Springbank Hill Community Association

June 1, 2017

RE: Springbank Hill ASP (M-2017-019)

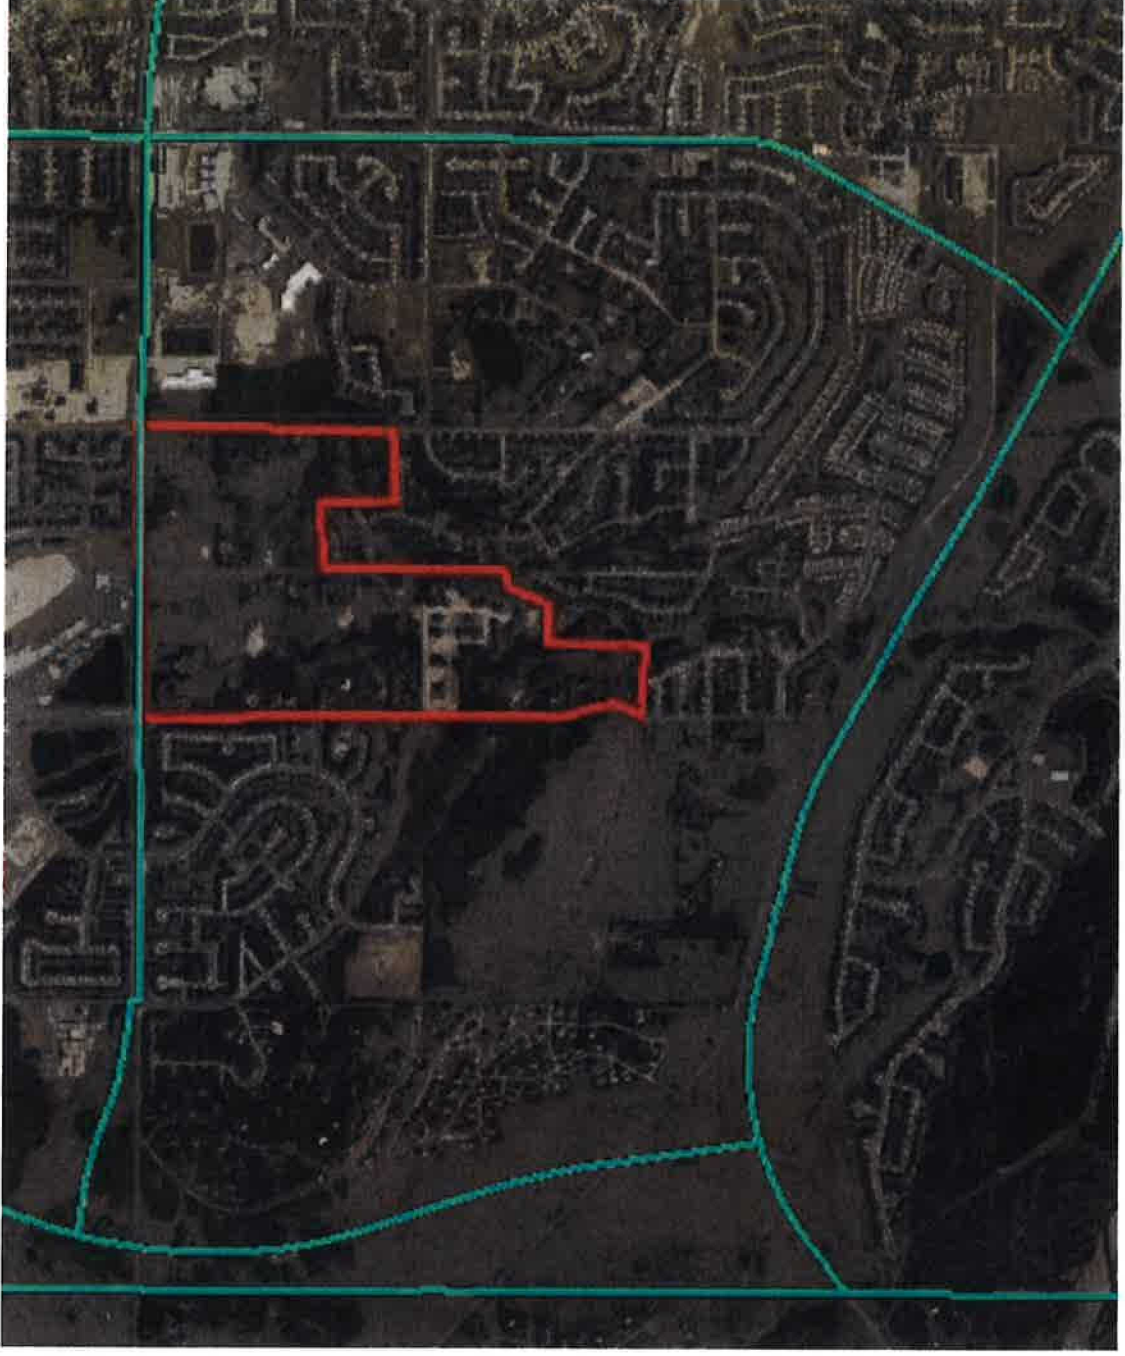
At CPC, the design of the NAC was substantially modified increasing the building height from 6 to 10 storeys.

Originally proposed to have maximum 6 storey buildings, given the footprint of this gathering area, having the NAC surrounded by 10 storey buildings will create an uninviting, unused space, constantly in shadows. The city planning department cannot provide any instances of a proposed NAC, with 10 storey buildings.

- The building height surrounding the NAC be lowered from 10 storeys (as per the proposed CPC amendments) to no more than 6 storeys (as per the April 11, 2017 ASP Draft from city administration), to provide for an attractive, usable gathering area as originally envisioned
